Blocks 2 & 3

Levels

Proposed Changes

Blocks 2 & 3 Overview

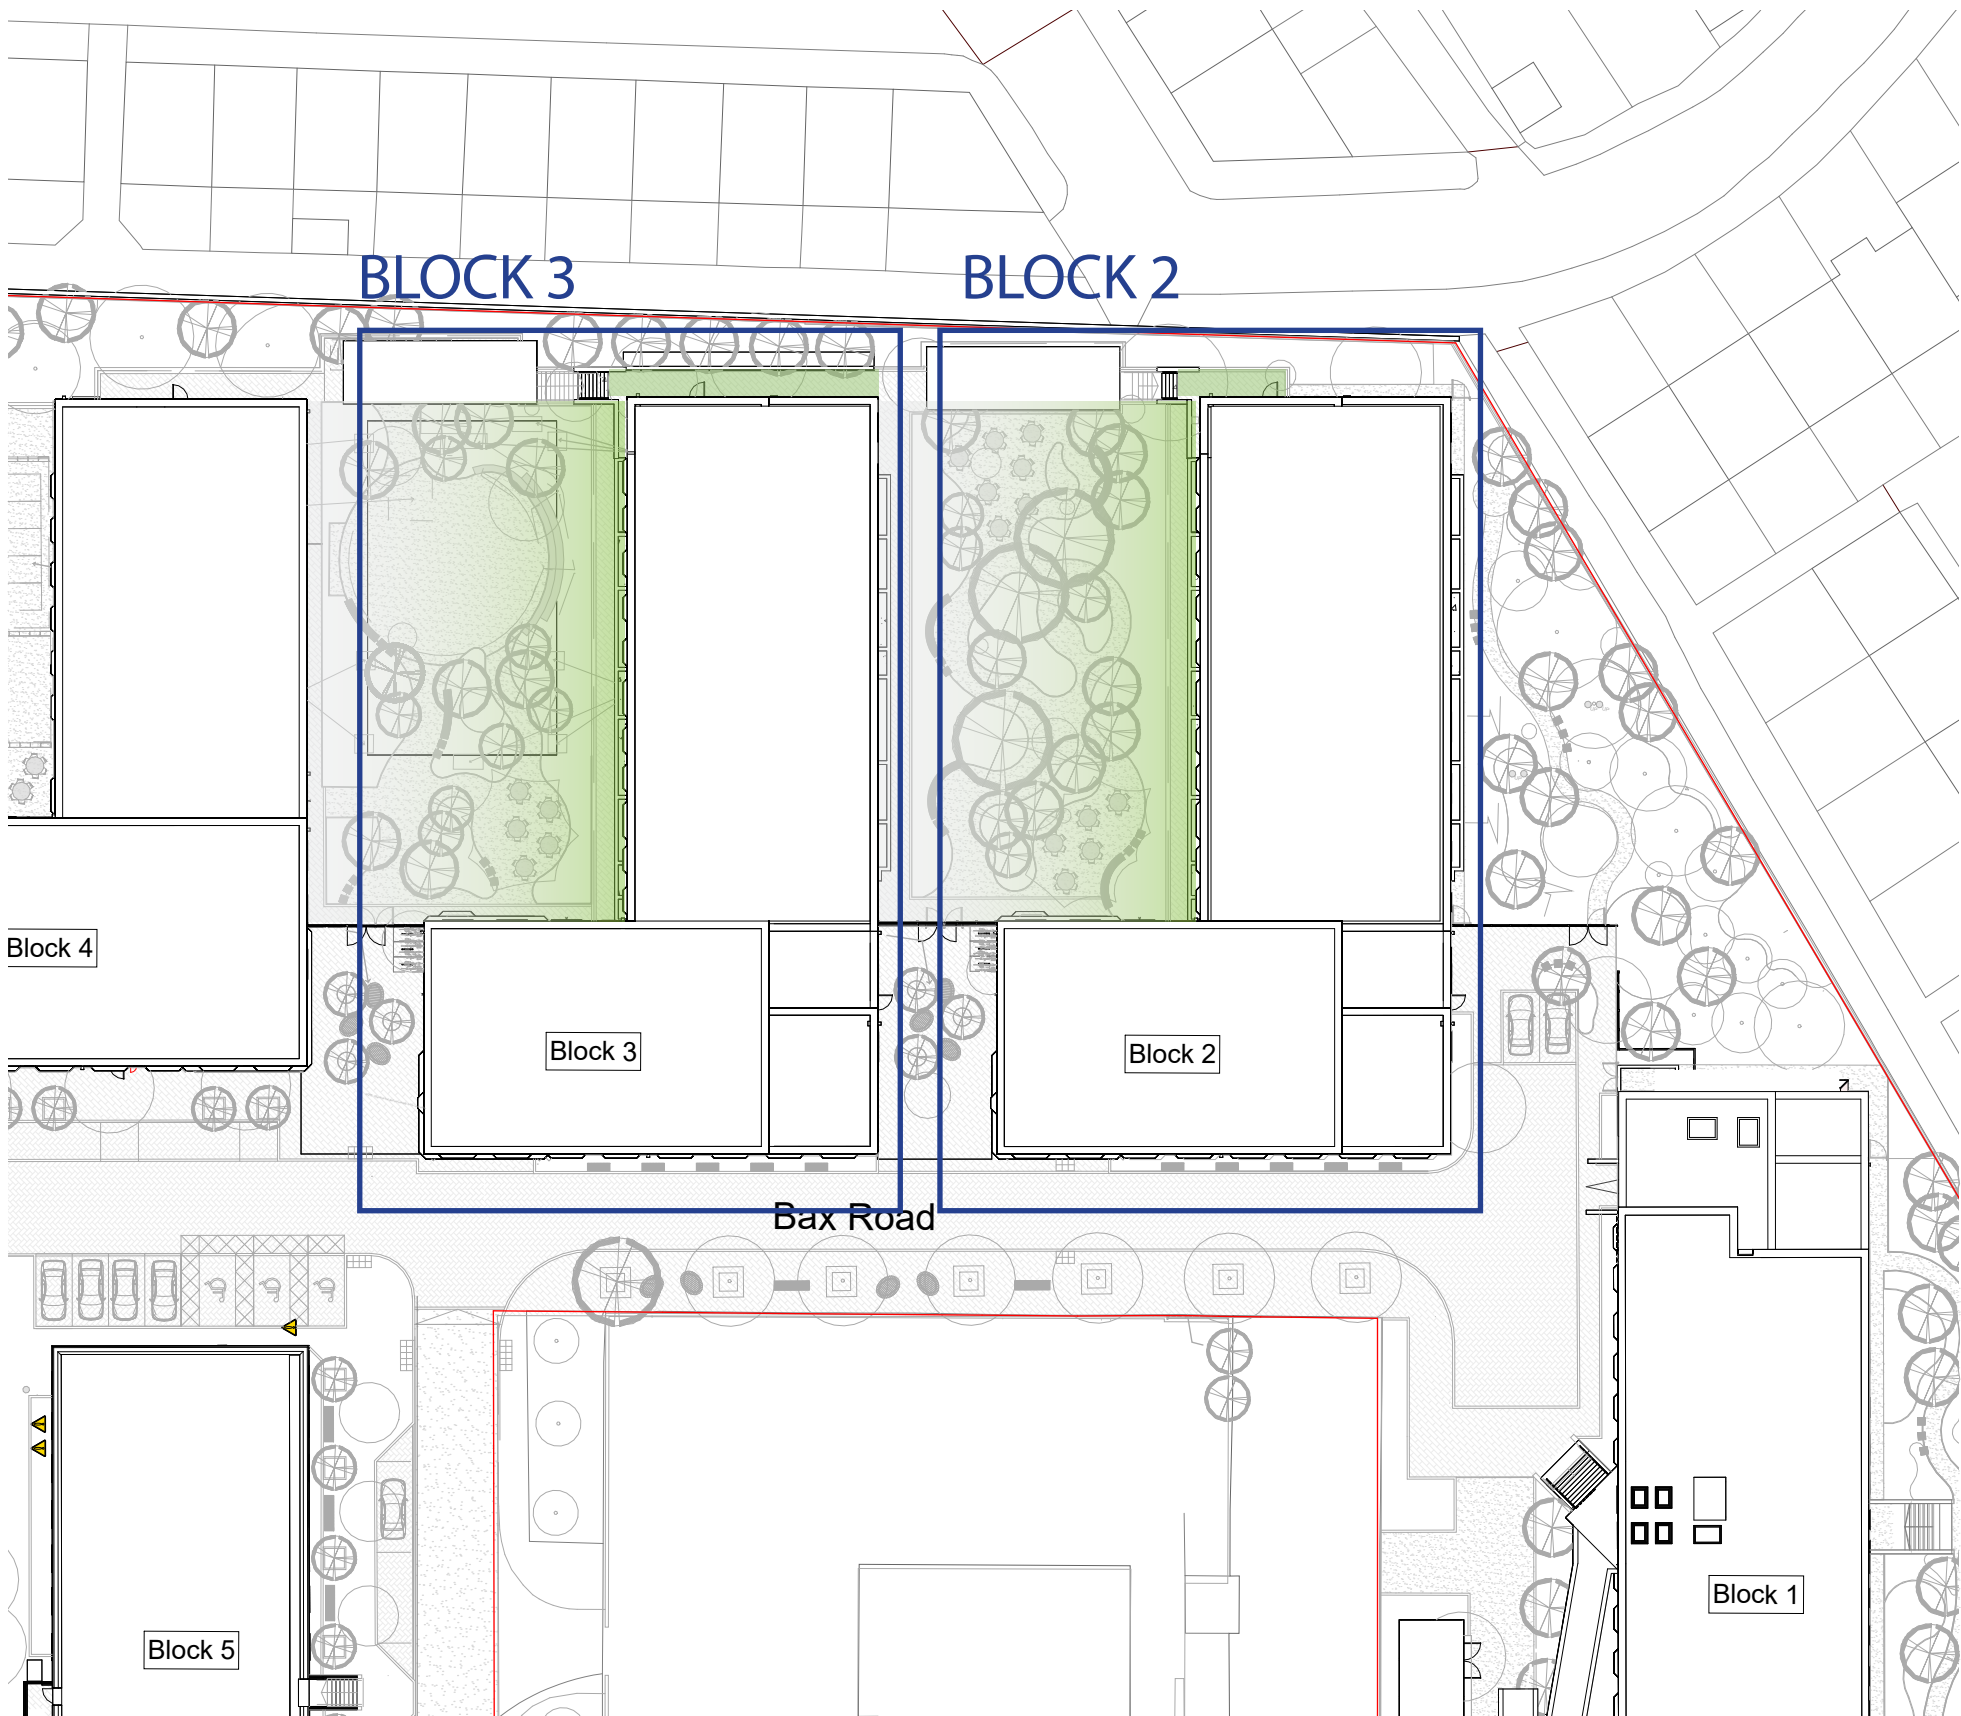
It is proposed that the levels within the courtyards and adjacent to Blocks 2 and 3 are to be regraded to the building edge. This approach will allow for a more usable and legible courtyard layout.

Below are some existing photos to show the existing condition, and in red the proposed adjustments.

Existing Site Photos

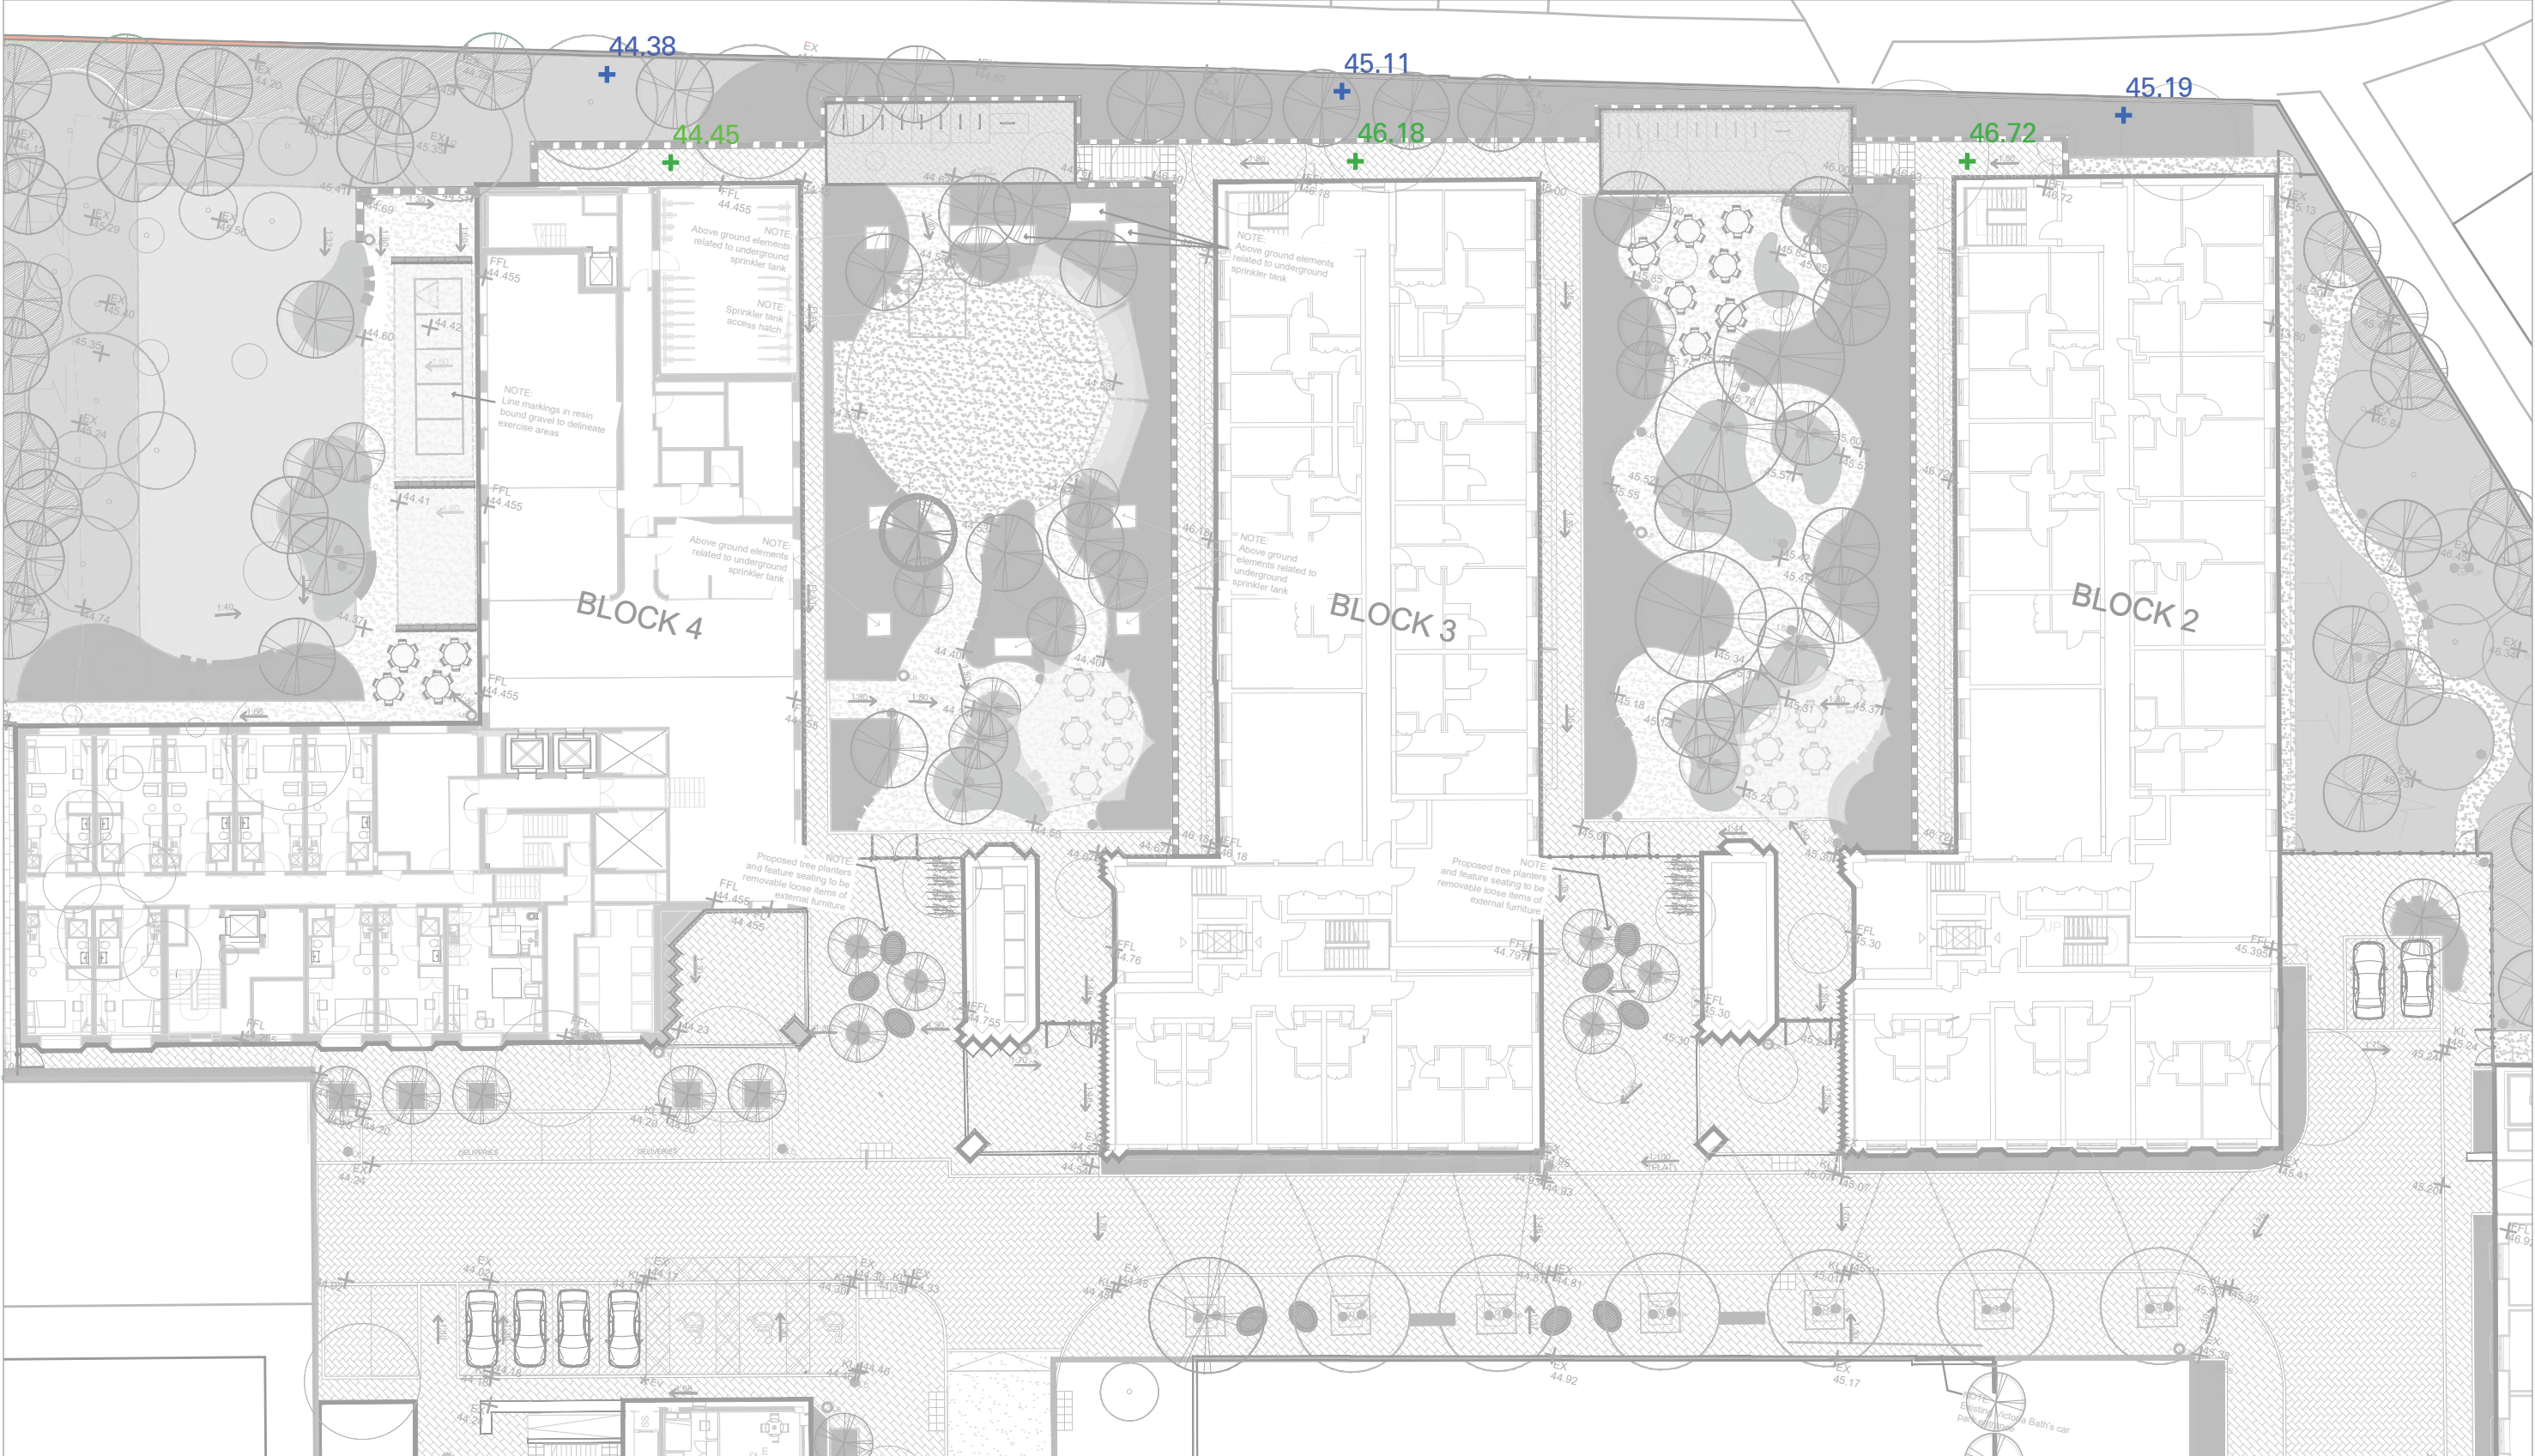
These existing site photos show the existing context in relation to the rear walls. Here we have indicated the approximate extent of the new path. These show the height in relation to the existing mounded earth. In the first image, it can be seen that the path sits at a height that is similar to the existing mounded earth. In the second image, the fire escape sits at the same level as the proposed path. The edge of the proposed path will sit 1.8m away from the rear of the existing building.

Indicative ground line - note, height of existing mounded earth is at same height as proposed path

Proposed Changes Rear Condition

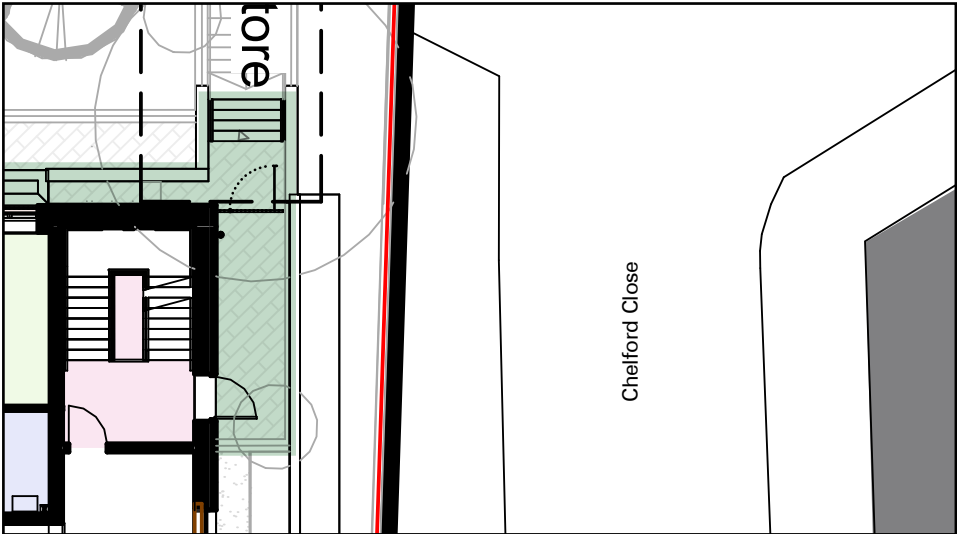
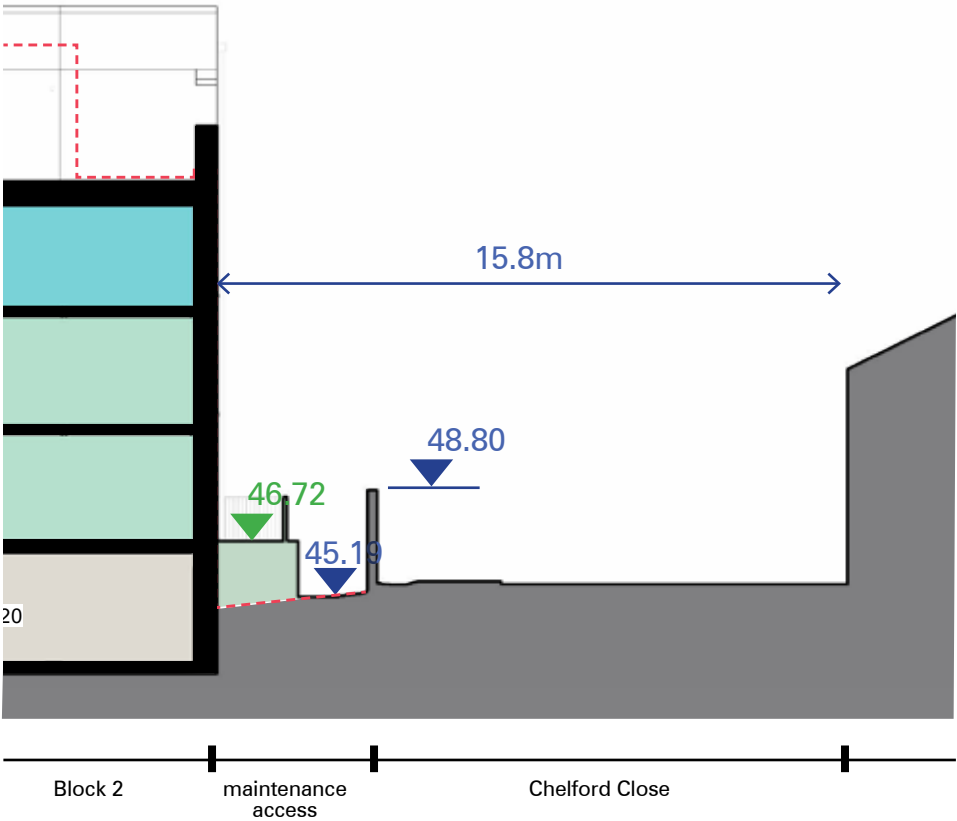
Existing Levels

Proposed Levels

Block 2

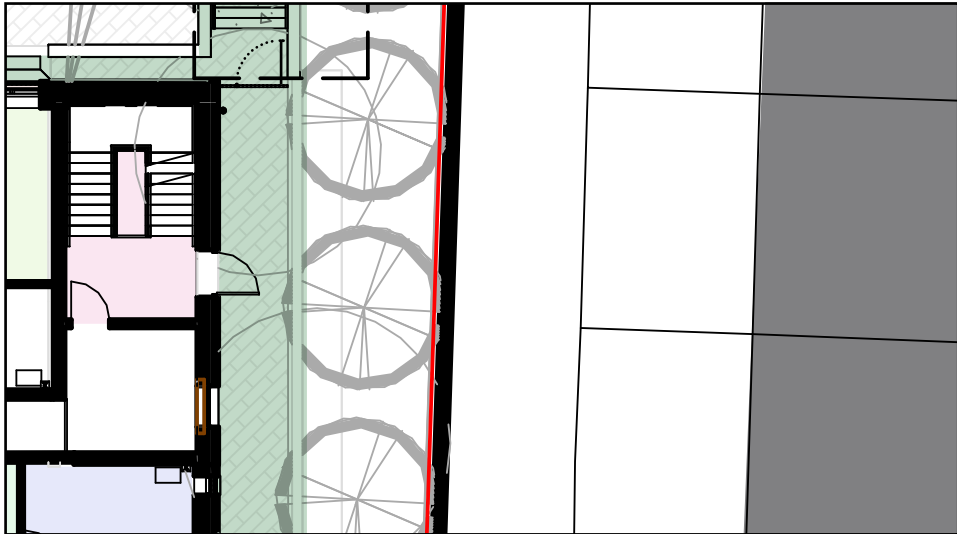
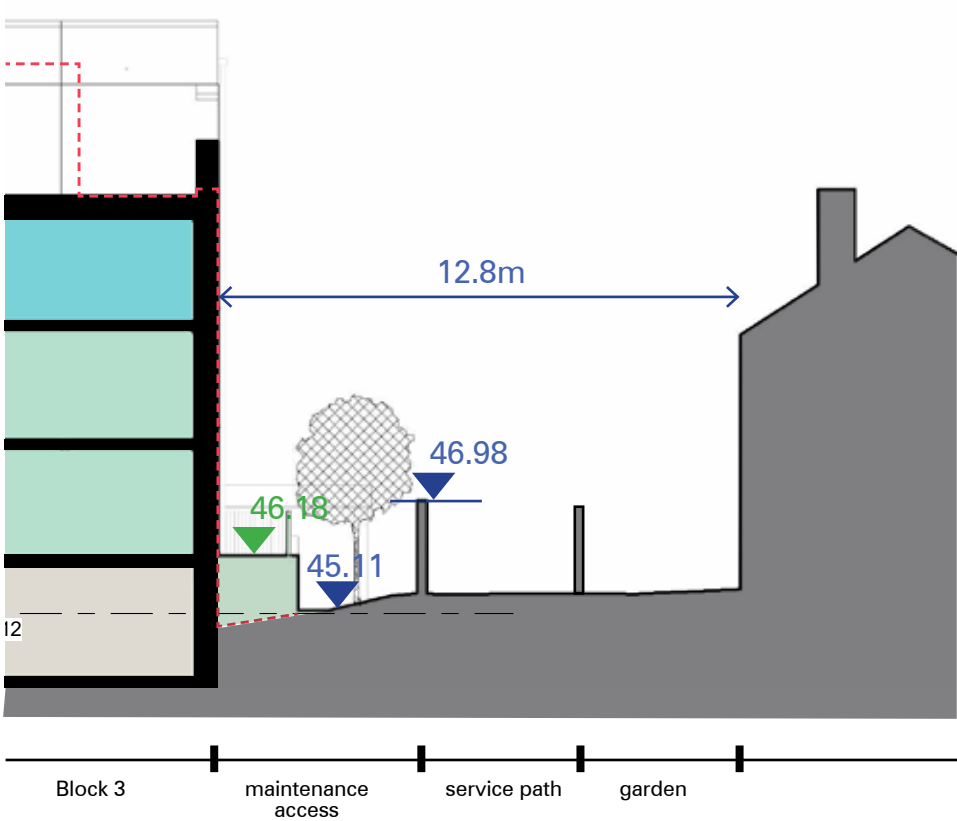
To facilitate the fire egress, a raised path is to be constructed. This extends to the door of the fire escape only. As is shown on the revised planning drawings, a low level gate is proposed which is on a sprung closer opening out from the means of escape. This gate restricts access to this path for residents. It defines what is publicly accessible and what is private space. The space will be CCTV monitored and residents will not be able to use this path, except in emergencies.

The raised path sits almost 2m lower than the top of the existing wall. The distance between Block 2 and the neighbouring building on Chelford Close is almost 16m. The risk of overlooking is therefore minimal.
